## ORIGINATION FORM

### Proposed Revisions to a Standard Plans Index

Index Number: 521-630

Index Title: PARAPET WITH C-I-P SIDEWALK - WALL COPING

**TYPICAL SECTION THRU PRECAST COPING/PARAPET WITH C-I-P SIDEWALK AND RETAINING WALL (MSE Wall Shown, other Wall Types Similar)**

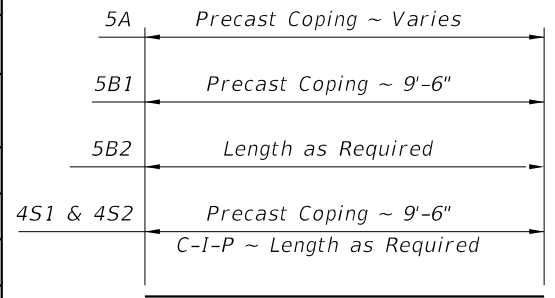
**CHANGED DEPTH TO: 18"**

**UPDATED TO: Shoulder Barrier**

**CHANGED DEPTH TO: 18"**

**ADDED DIMENSION: 3'-3"**

**REINFORCING STEEL BENDING DIAGRAMS - COPING/PARAPET AND SIDEWALK**

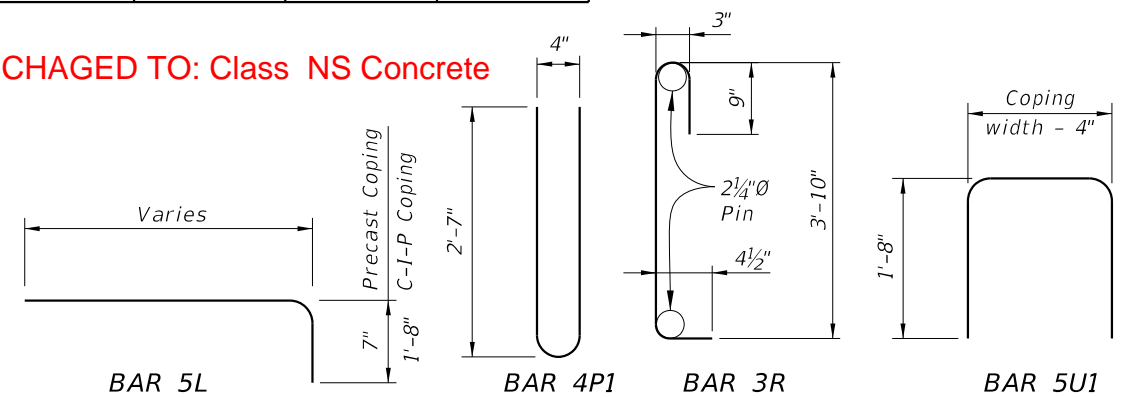
**CHANGED TO: Class NS Concrete**

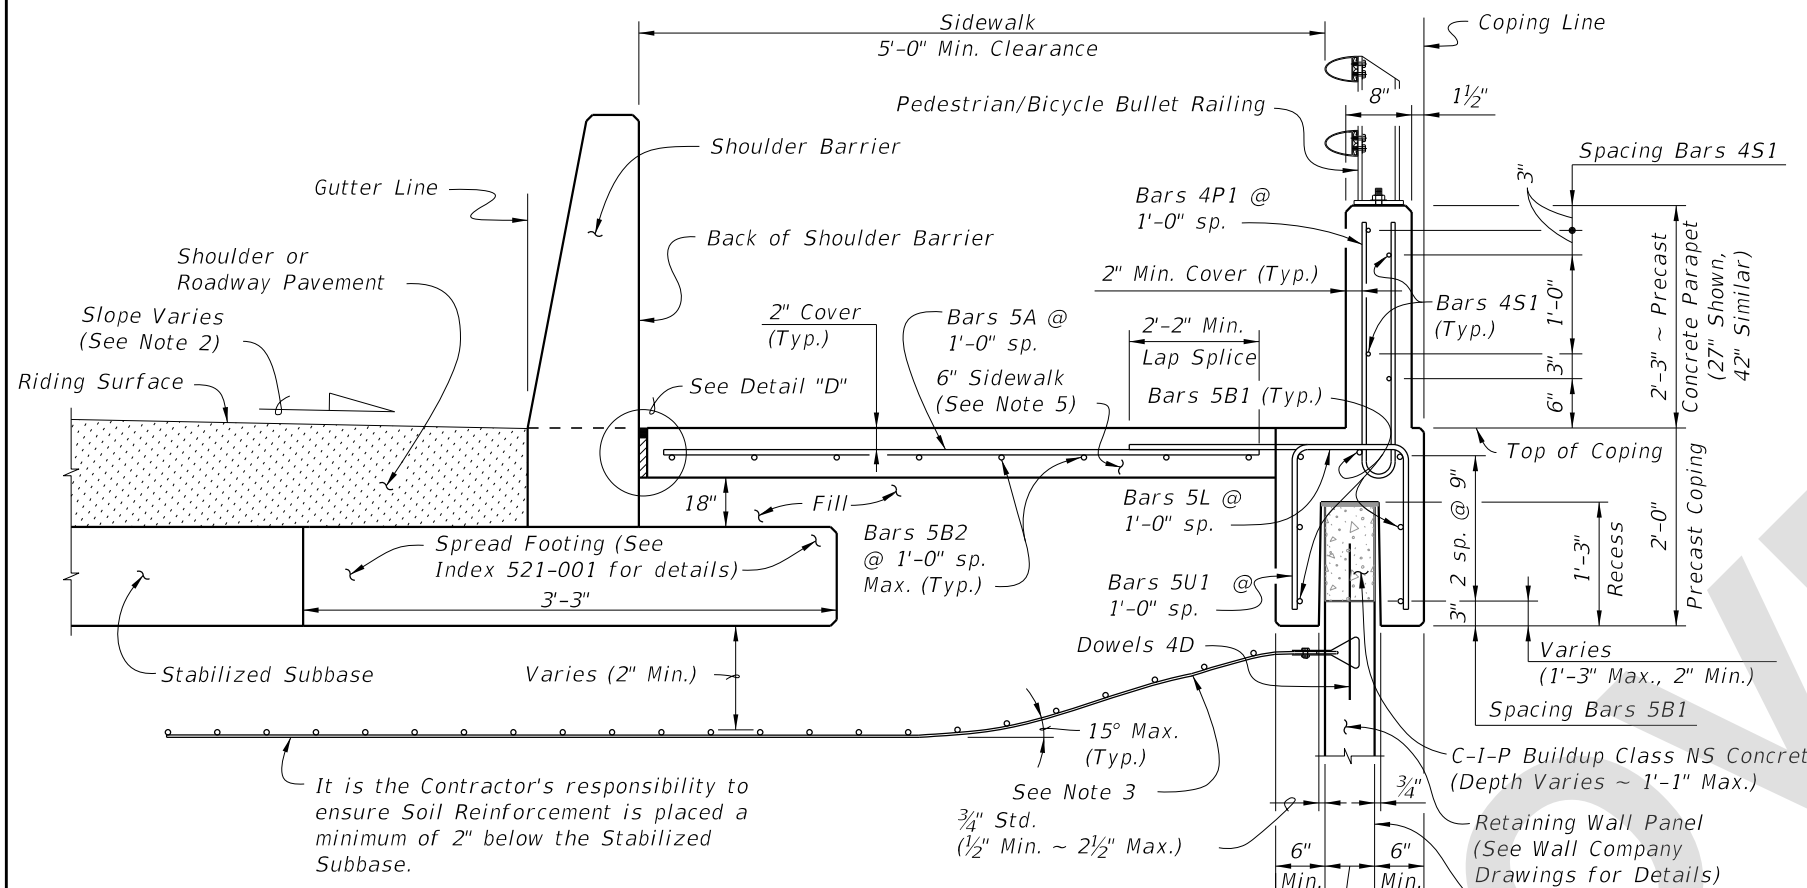
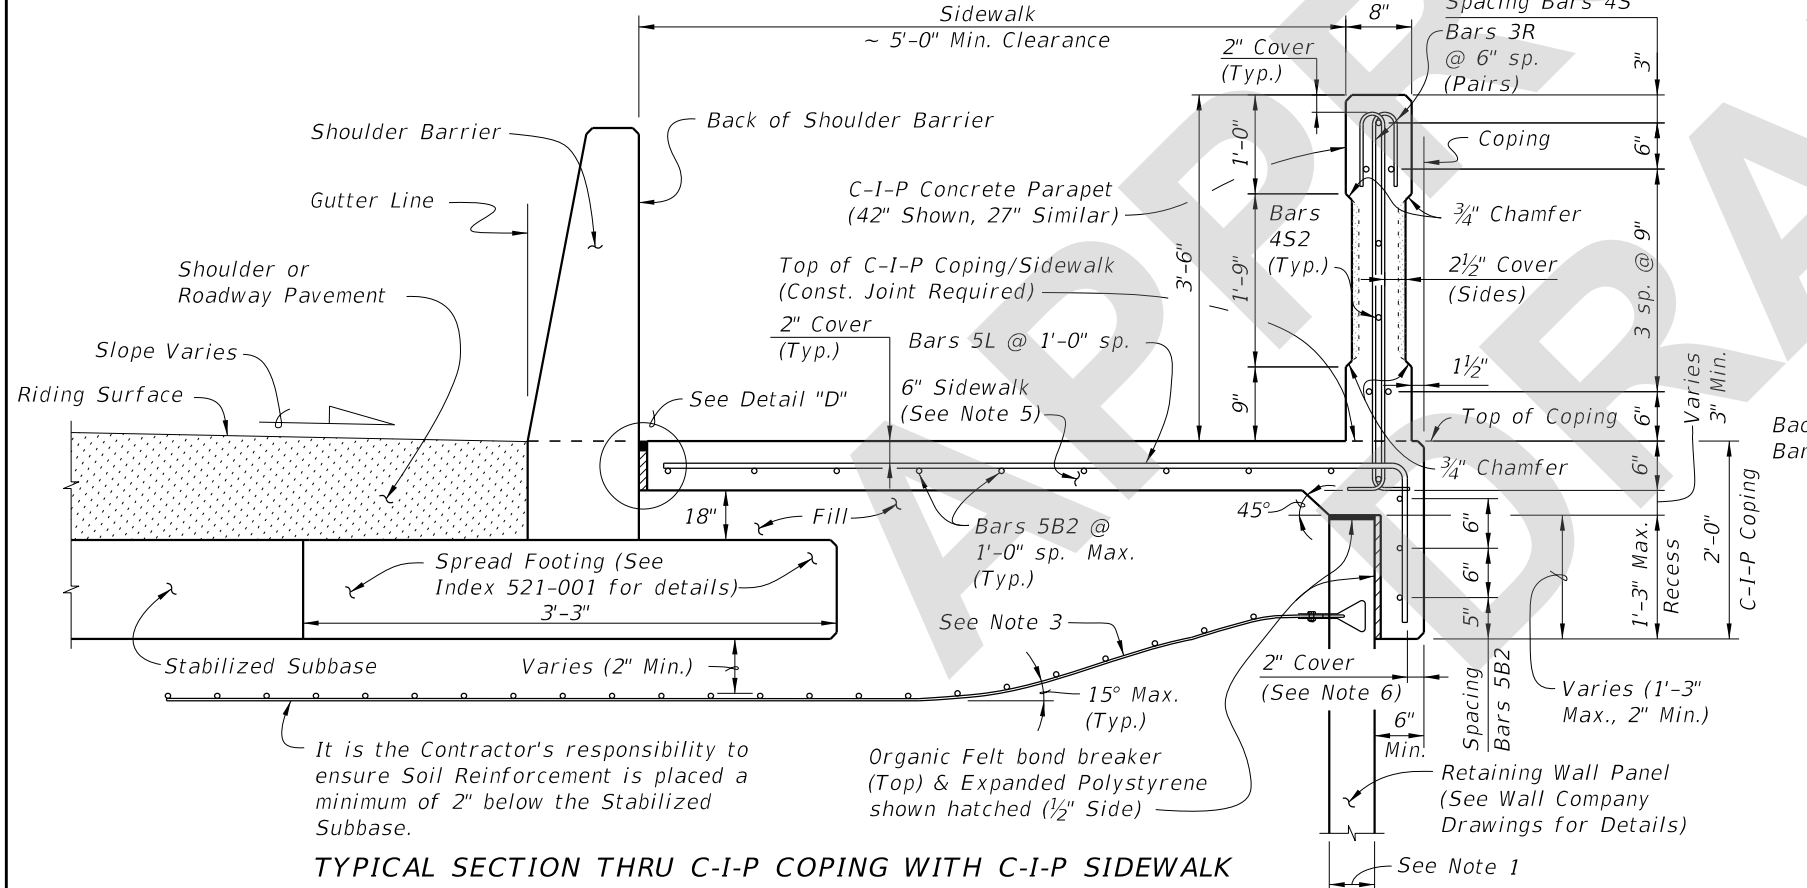
Changed footing depth below sidewalk to 18" from 10"; Updated the name of the barrier to Shoulder Barrier from Concrete Barrier Wall; Changed C-I-P Buildup Concrete (1'-1" Max.) callout in the TYPICAL SECTION THRU PRECAST COPING/PARAPET WITH C-I-P SIDEWALK AND RETAINING WALL to C-I-P Class NS Concrete (1'-1" Max.)

This Standard needed some updating to keep consistency with current barrier footing dimensions.

CIP buildup concrete type was never clarified. SDO review deems Class NS is acceptable because the concrete buildup section is not meant to transfer any meaningful load to the wall other than self weight.
